Access Compliance Report Public Rights-of-Way (Curb Ramps)

Main Street: ST_BRIDE_WAY Cross Street: ST_JUST_ST Location: SE

ADA ID: RPRK211110133925 Ramp Type: Type 4 - Parallel Initial Pass/Fail: Fail Overall Compliance: No Severity Score: 2

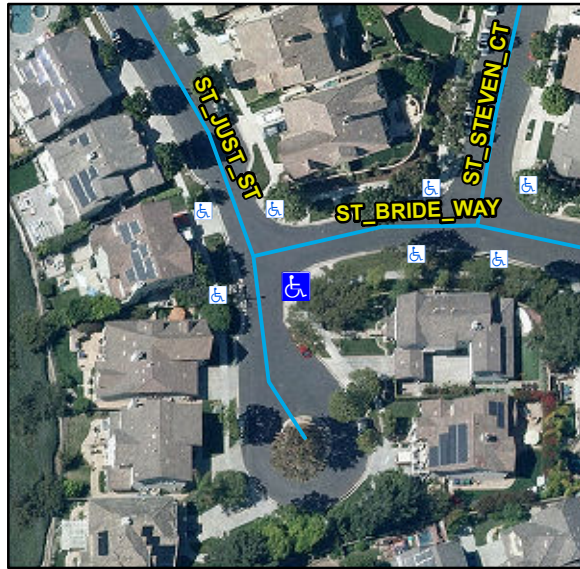
Compliance	Description	Data	Compliance	Description	Data
N/A	Ramp Length LT (in)	132	N/A	Ramp Length RT (in)	124
Yes	Ramp Width LT (in)	53	Yes	Ramp Width RT (in)	53
Yes	Ramp Run Slope LT (%)	4.4	Yes	Ramp Run Slope RT (%)	7.3
No	Ramp Cross Slope LT (%)	2.8	Yes	Ramp Cross Slope RT (%)	0.5
N/A	Landing Present	N/A	N/A	DWS Provided	N/A
N/A	Landing Length (in)	N/A	N/A	DWS Contrast	N/A
N/A	Landing Width (in)	N/A	N/A	DWS Length (in)	N/A
N/A	Landing Run Slope (%)	N/A	N/A	DWS Full Width	N/A
N/A	Landing Cross Slope (%)	N/A		DWS Offset Type	N/A
N/A	Landing Movement Obstructed?	N/A	N/A	DWS Offset Left (in)	N/A
	Landing Movement Type	N/A	N/A	DWS Offset Right (in)	N/A
N/A	Landing Shared	N/A			
N/A	Clear Space	Yes			
N/A	Clear Space To Crosswalk (in)	N/A			
N/A	Marked Crosswalk 1	No	N/A	Marked Crosswalk 2	No
	Crossing 1 Direction	N		Crossing 2 Direction	W
	Marked Crosswalk 1 Width (in)	N/A		Marked Crosswalk 2 Width (in)	N/A

Remove & Replace Curb Ramp With Two New Directional Ramps or Equivalent.
